**SINCLAIR CENTRE
REVITALIZATION PROJECT
757 W HASTING ST. VANCOUVER**

**SECTION 10 AND X - X REVISED
(XREF. DWG. S313)**

**SINCLAIR CENTRE
 REVITALIZATION - PHASE 2**

Revision/	Description/Description	Date/Date
2	ISSUED FOR MECHANICAL ADDENDUM #2	2013/06/12
1	ISSUED FOR MECHANICAL ADDENDUM #1	2013/06/04
0	ISSUED FOR TENDER	2013/04/24
Client/client

PARTIAL SECTION A - A REVISED
(XREF. DWG. S416)

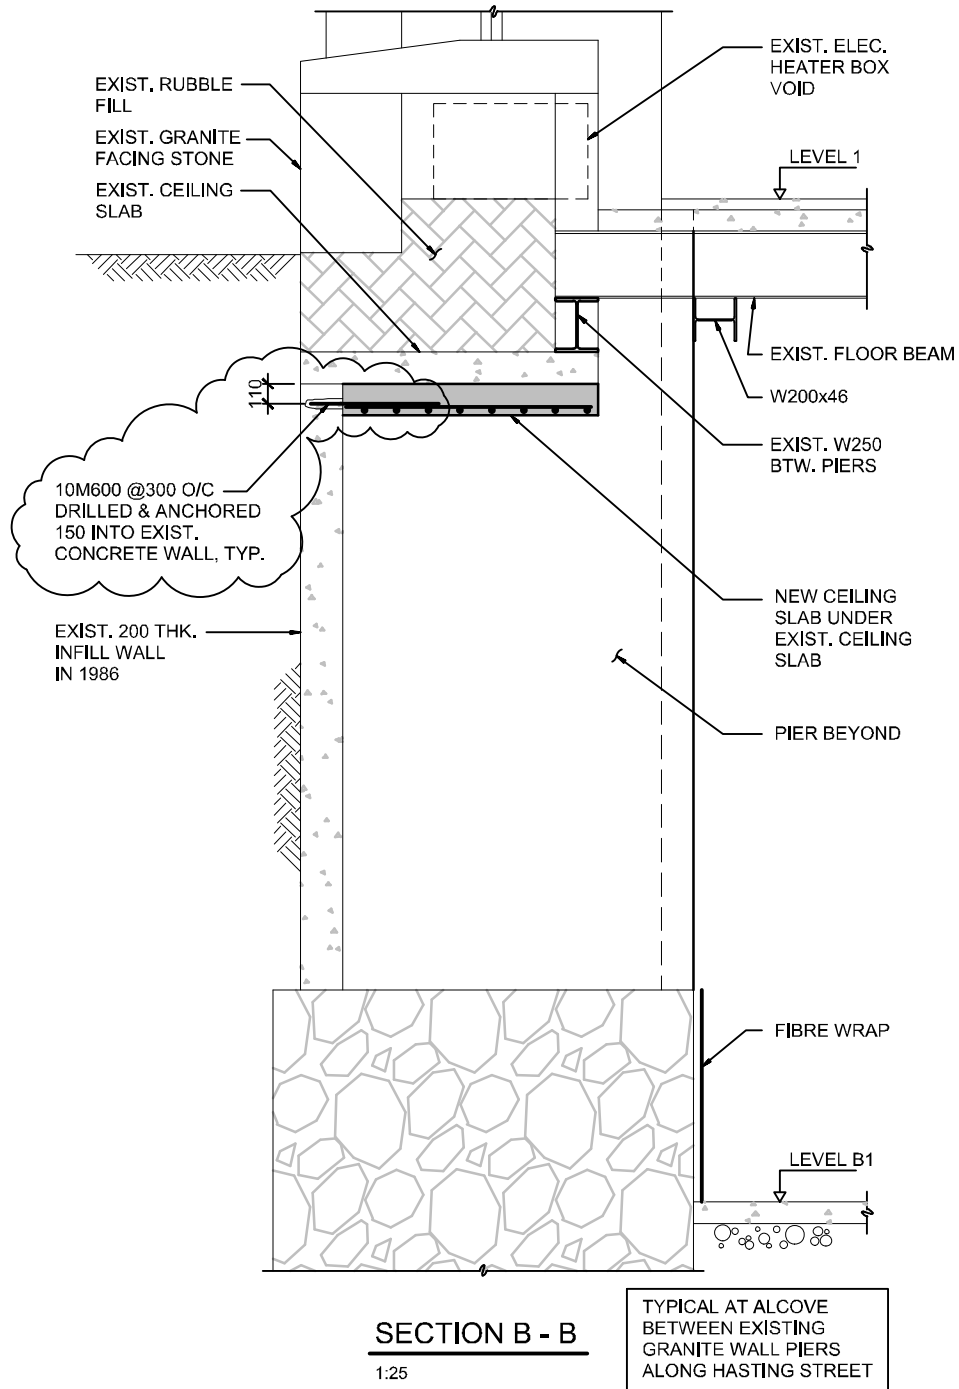
TYP. FOR WALL PIERS W/ EX

TYP. FOR PERIMETER WALLS ALONG HASTINGS

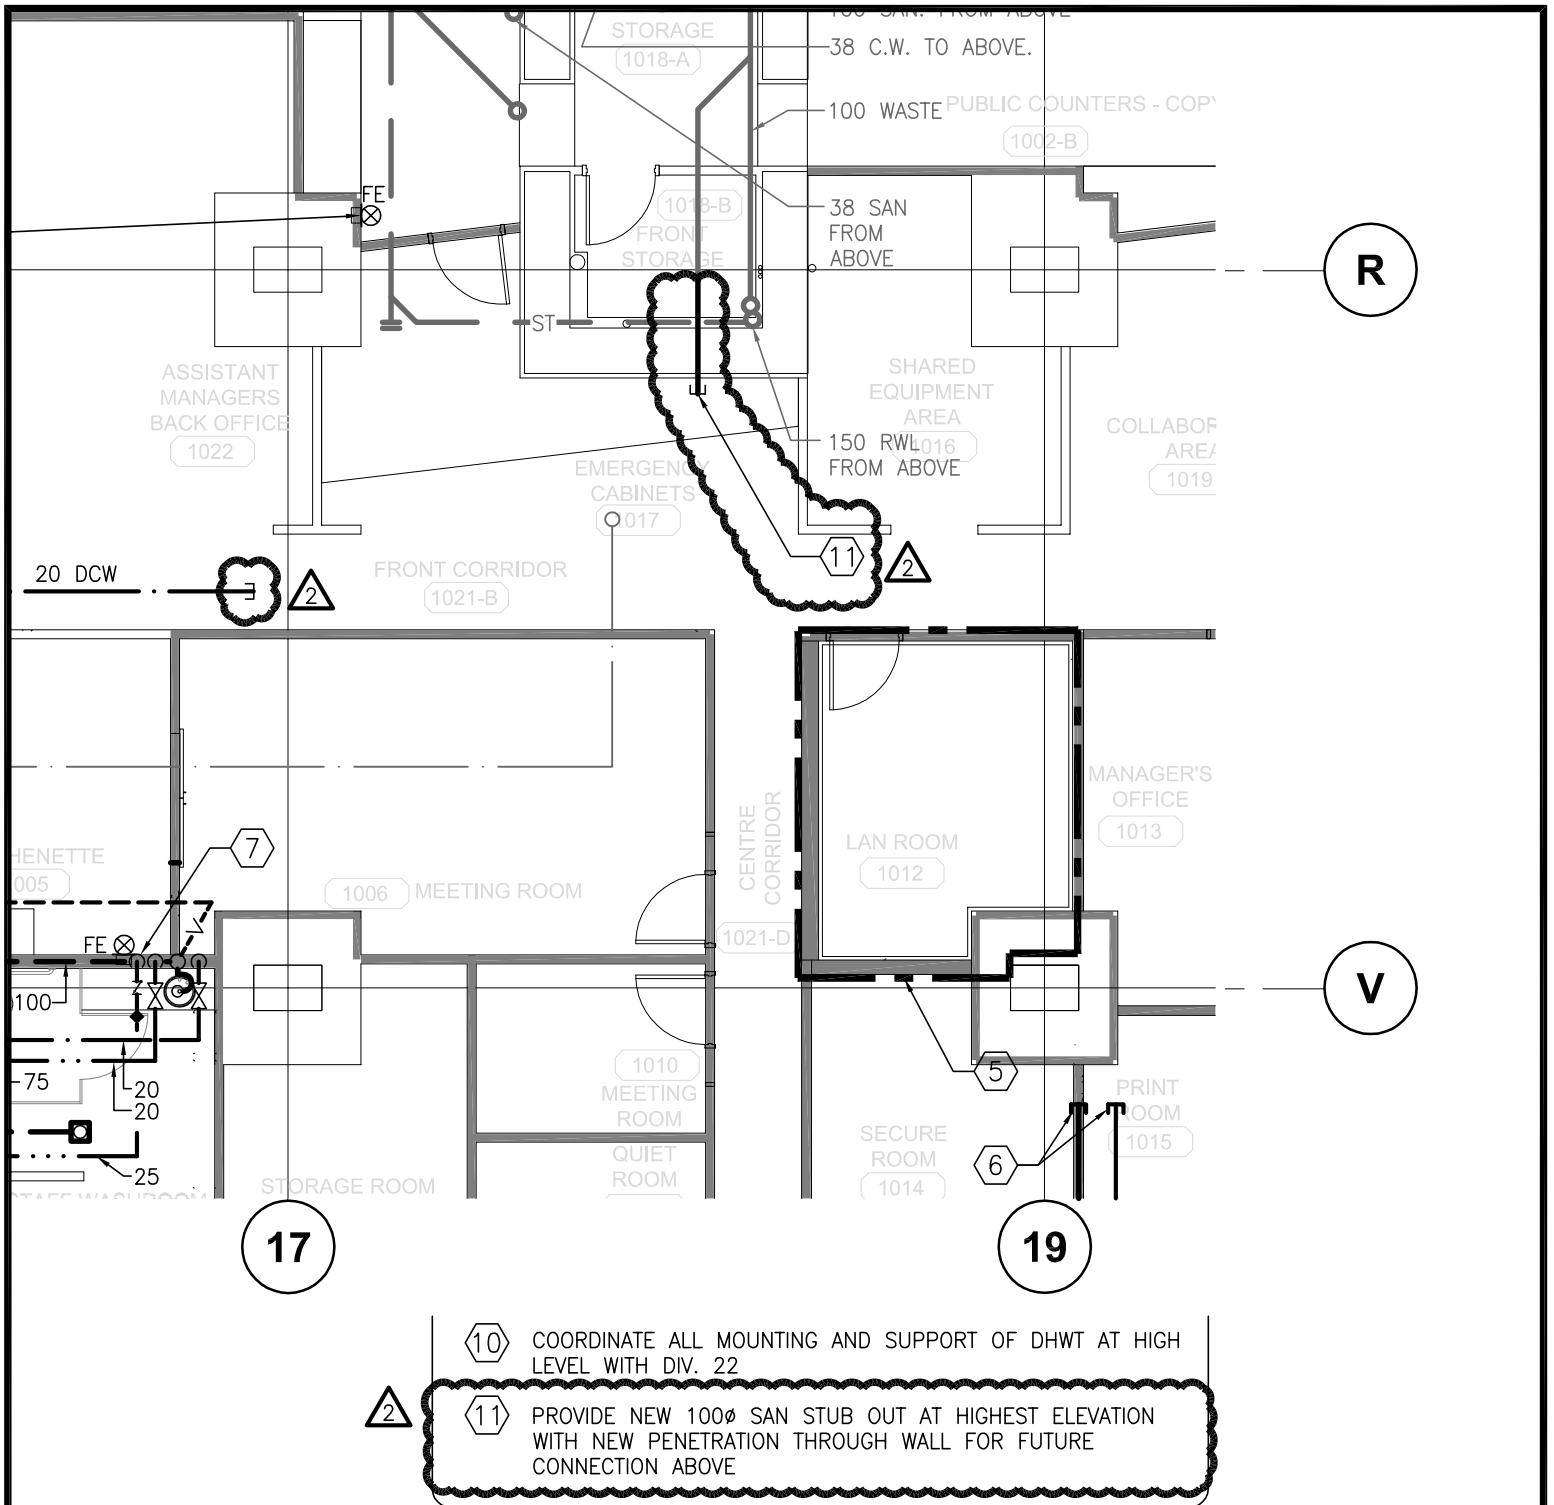
5. CONTRACTOR TO ALLOW FOR RE-HANGING OF ALL PLUMBING PIPING APPROXIMATELY 300MM LOWER (FINAL DISTANCE TO BE DETERMINED ON SITE) TO ACCOMMODATE STRUCTURAL SEISMIC UPGRADES. REFER TO STRUCTURAL DRAWINGS FOR COORDINATION AND MORE INFORMATION.

VERIFY AND DEMOLISH ALL EXISTING SANITARY DRAINAGE SERVING FIXTURES ON THE ESCADA SPACE ABOVE. ALLOW FOR CAP-OFF OF HOT AND COLD WATER SERVING THE FIXTURES ABOVE.

1 FIRE PROTECTION - POST OFFICE - LEVEL B1
M1.03 SCALE: 1:100

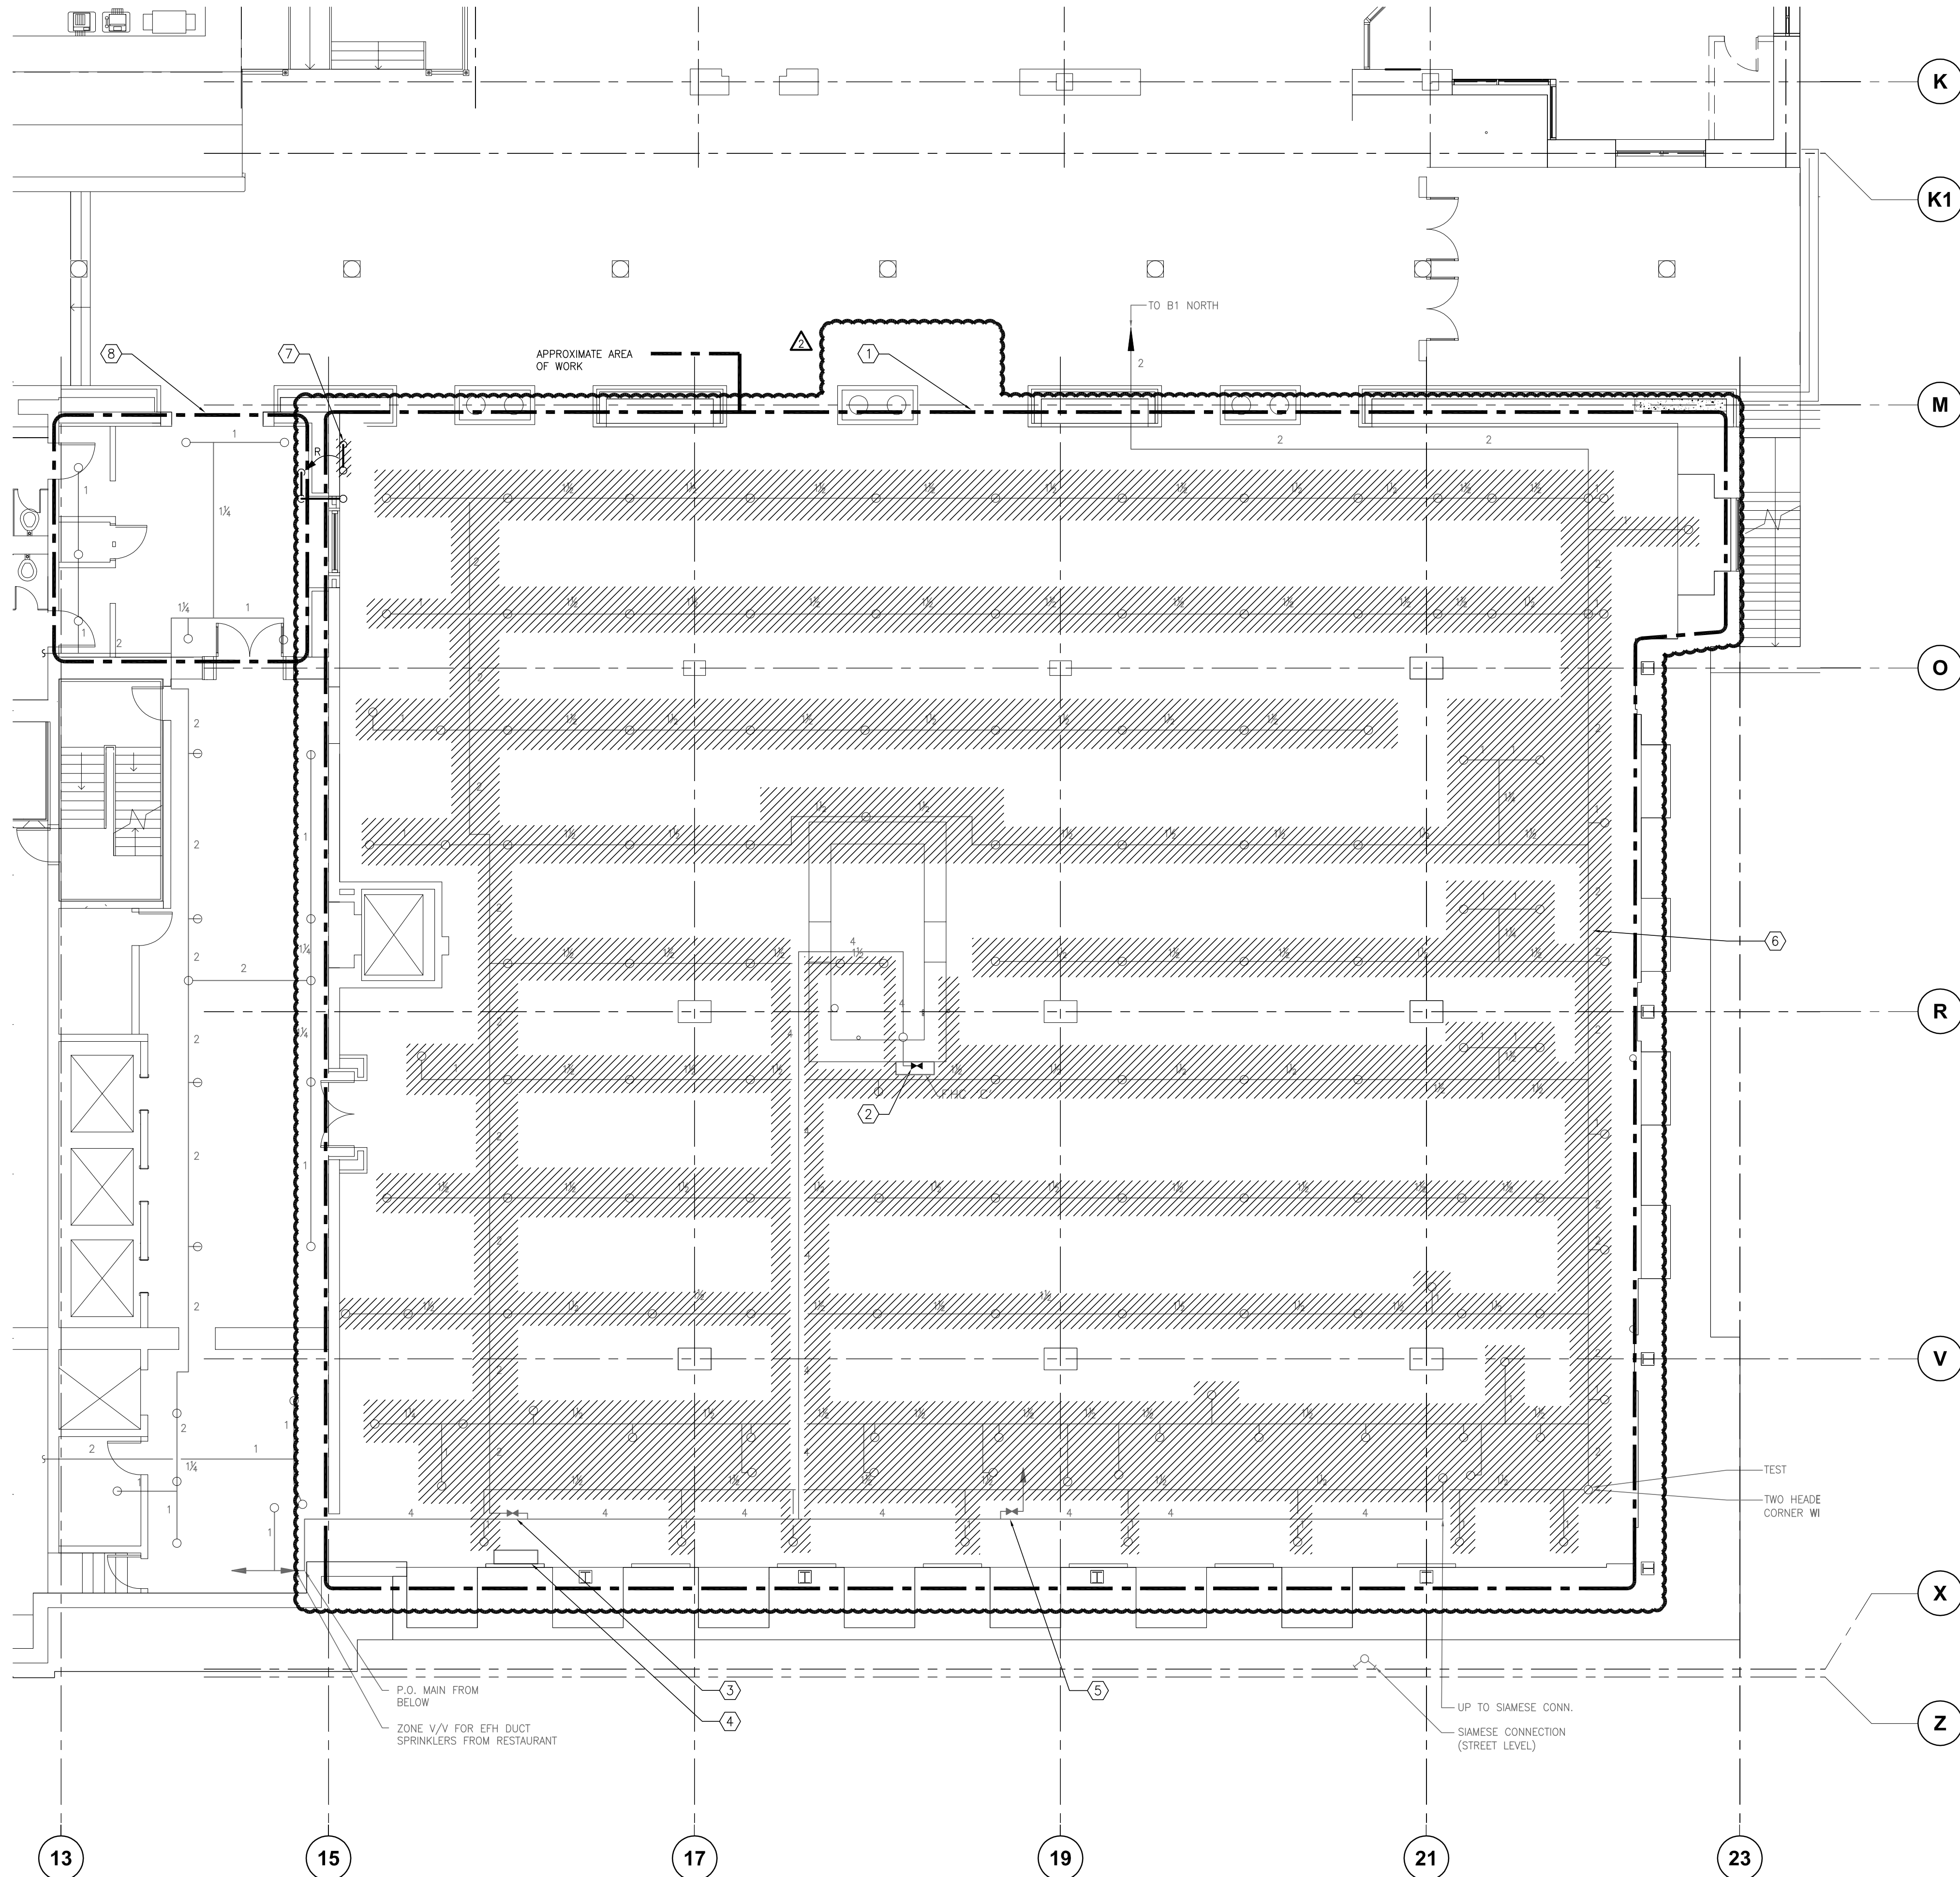
- PROVIDE DEMOLITION OF ALL EXISTING SPRINKLER PIPING, HEADS, VALVES, ETC. AND PROVIDE ALL NEW SPRINKLER COVERAGE TO NFPA 13 REQUIREMENTS, INCLUDING ALL FIRE PROTECTION NOTES ABOVE. ALLOW FOR RE-ROUTING OF EXISTING OF PIPING TO OTHER ZONES TO PROVIDE REQUIRED CLEARANCES FROM NEW SERVICES AND STRUCTURAL UPGRADES. SEE STRUCTURAL DRAWINGS FOR MORE INFORMATION.

- RE-LOCATE EXISTING FIRE HOSE CABINET IN COORDINATION WITH ARCHITECTURAL DRAWINGS.
- RECOMMISSION EXISTING FLOW AND TAMPER SWITCHES
- REMOVE EXISTING KITCHEN HOOD FIRE SUPPRESSION CONTROL PANEL. COORDINATE WITH ELECTRICAL TRADE, INCLUDING DISCONNECTION FROM FIRE ALARM PANEL.

- DISCONNECT ZONE VALVE AND FLOW SWITCH FOR EF11 DUCT SPRINKLERS FROM FIRE ALARM PANEL AND REMOVE SPRINKLERS FROM DEMOLISHED EF-11 KITCHEN EXHAUST DUCTWORK

- PROVIDE NEW TEST DRAINS & ZONE DRAINS FOR THIS AREA. COORDINATE EXACT LOCATION WITH DEPARTMENTAL REPRESENTATIVE.
- ALLOW FOR RE-LOCATION AND DIVERSION (ALLOW 10M, EIGHT (8) ELBOWS) OF 100# SPRINKLER LINE SERVING ESCADA SPACE TO OPPOSITE SIDE OF WALL TO ALLOW ROOM FOR SEISMIC UPGRADE WORK, INCLUDING SLEEVE THROUGH NEW WALL AND OFFSET ON THE FLOOR ABOVE. REFER TO STRUCTURAL DRAWINGS FOR MORE INFORMATION. IN ADDITION, ALLOW FOR OFFSET OF PIPE AT HIGH LEVEL ON FLOOR ABOVE FROM

- ALLOW FOR RE-WORK OF SPRINKLER HEADS AND PIPING IN THIS ALCOVE TO ALLOW FOR SEISMIC UPGRADES AND TO SUIT ARCHITECTURAL CHANGES TYPICAL FOR FLOOR ABOVE. SEE ARCHITECTURAL DRAWINGS FOR DETAILS
